BRAKE HOSE INSPECTION

Prevost vehicles

DESCRIPTION

Figure 1

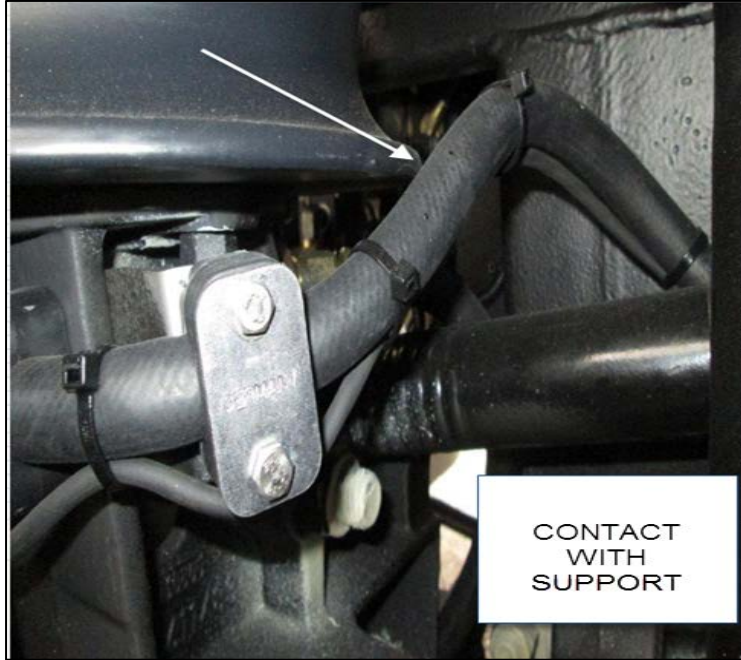
1. On each side of the vehicle, make sure that the brake hose to the brake booster does not come into contact when suspension is in low or high buoy.
2. If no contact is found, end the bulletin here.

Figure 2

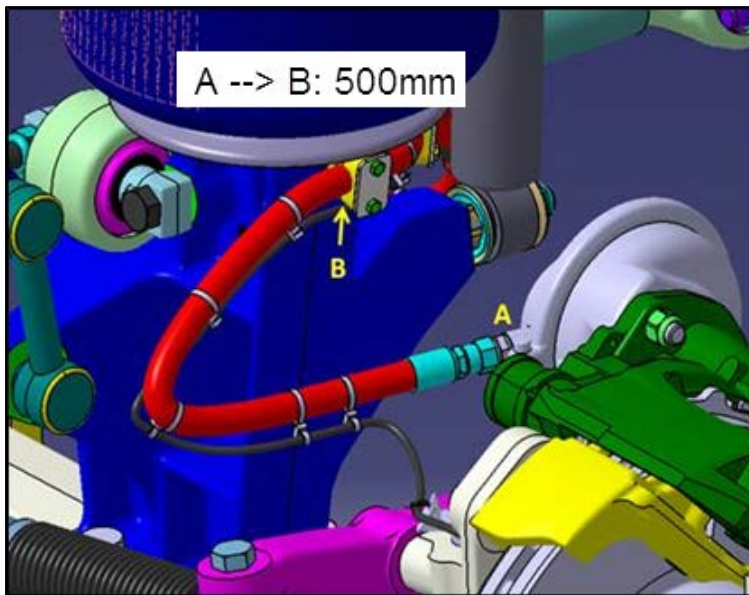
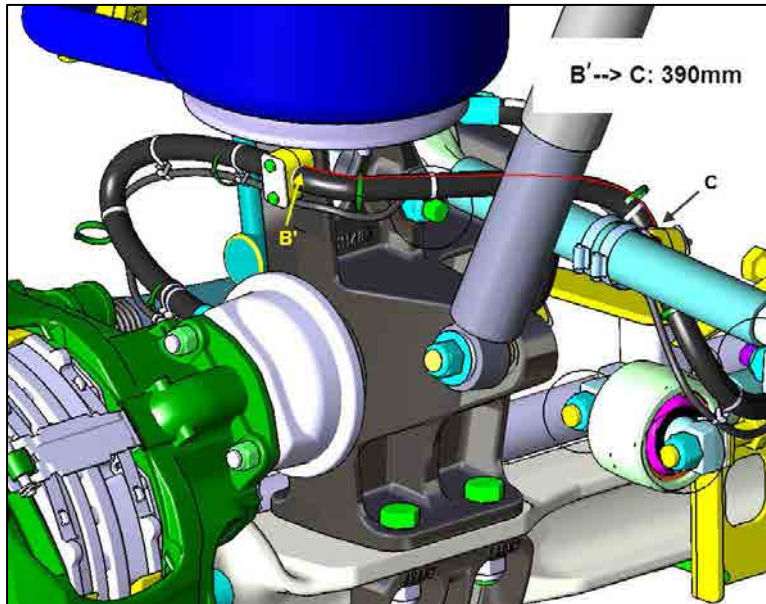
3. If there is interference, reposition the hose on each side of the vehicle as shown in fig. 2 and 3.

4. Measure and mark distances below on hose and adjust hoses as required to avoid interference.
 - From A to B: 500mm (19 5/8")
 - From B' to C: 390mm (15 3/8")
